U.S. Department of the Interior BUREAU OF LAND MANAGEMENT Sundry Print Reportu

Well Name: POLES PARADISE Well Location: T30N / R14W / SEC 9 / County or Parish/State: SAN

Notice of Intent

Type of Action: Plug and Abandonment

Planned P & A Wellbore Schematic

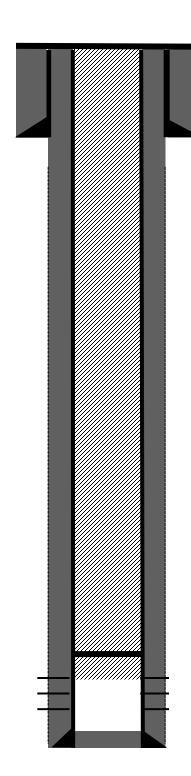
- 1. Plugging operations authorized are subject to the attached "General Requirements for Permanent Abandonment of Wells on Federal and Indian Lease."
- 2. The following modifications to your plugging program are to be made:a. Complete well bore fill up proposal. No changes to the procedure.
- 3. Notification: Farmington Office is to be notified at least 24 hours before the plugging operations commence at (505) 564 7750.

Remarks:	Reference Well:
Complete wellbore fill up proposal. No changes to the procedure.	NA
	Prepared by: Kenneth Rennick
